# Staff Report

## Infill Housing Design Review Committee

File Number: 9-A-23-IH

New duplex fronting Johnston Street. Two story, front-gable roof residence measures 36' wide by 34' long, with a hipped-roof porch projecting approximately 6.5' and extending the length of the facade. The structure is proposed to be set 49' from the front property line. Parking is proposed to be a 1,444 square foot asphalt parking lot located in the front of the structure and accessed via Johnston St.

## SITE PLAN

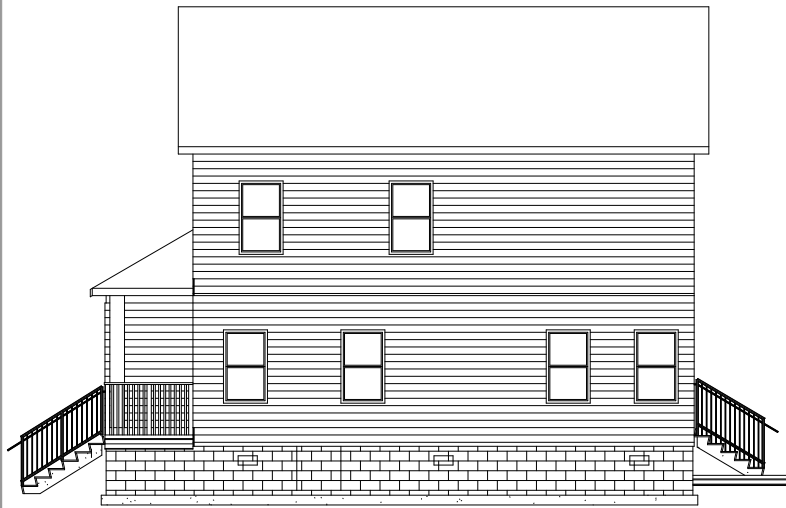
1. The house is proposed to be set 49' from the front property line. The average front setback of the block is 37'. The house should be moved towards the front property line to maintain a consistent streetscape pattern, which would also allow space for a parking area in the rear. The site plan should include a walkway to the street.

3. As proposed, the parking does not meet Infill Housing design guidelines. The parking area should be moved to the rear of the building, which would allow for a single driveway alongside the house and a turnaround area in the rear. Final revisions to the site plan will be necessary to meet City Engineering standards.

5. The site plan includes a 6.5' deep front porch; guidelines recommend at least an 8' deep front porch so residents can comfortably use the porch. The front porch should be increased in depth. Porch posts should be increased to at least 8 by 8s to be proportionate to the building. Four posts instead of two would also add detail to the house.

9. The final site plan should include one new native or naturalized shade tree to be planted in the front and rear yards.
10. As a duplex in the RN-2 zone, the project is subject to a Special Use review with the Planning Commission. Final revisions may be necessary to ensure the project meets the principal use standards for two-family dwellings.

Staff recommends approval of Certificate 9-A-23-IH, subject to the following conditions: 1) front setback to be revised to reflect existing streetscape pattern; 2) parking placement to be revised, placed in the rear of the lot; 3) final site plan to meet City Engineering standards; 4) front porch to be increased in depth to at least 8' and be supported by 8 by 8 posts; 5) revision to second-story façade windows; 6) duplex to receive special use approval by Planning Commission and meet the principal use standards for two-family dwellings.

Front Exterior Elevation  
Scale:  $\frac{1}{2}" = 1'-0"$

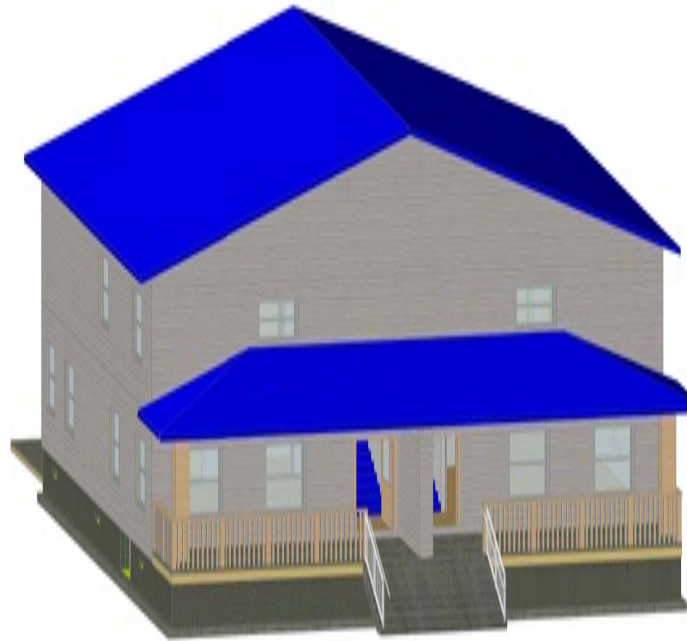
4. The two-story, six-bay façade is wider in scale than the context; however, the building is a duplex and not a single-family house. As depicted, the foundation height is compatible with original houses in the neighborhood.

6. Guidelines recommend window and door styles be similar, with similar proportions and ratio of solid to void, to historic houses on the block. Overall, the design includes sufficient windows on each elevation. Revisions should be made to the second-story windows on the façade; the windows should be increased in size to match the second story, and centered above the interior windows. Two additional windows may also benefit the large swath of siding without transparency.

7. The proposed 6/12 pitch roof meets the Infill Housing design guidelines.
8. The application does not include information on siding or roofing materials. If vinyl siding is used, the siding should feature an overlap instead of Dutch lap or flush panel siding. The CMU foundation should be clad in stucco or brick. Additional siding details on the second story may benefit the wide mass of the house.
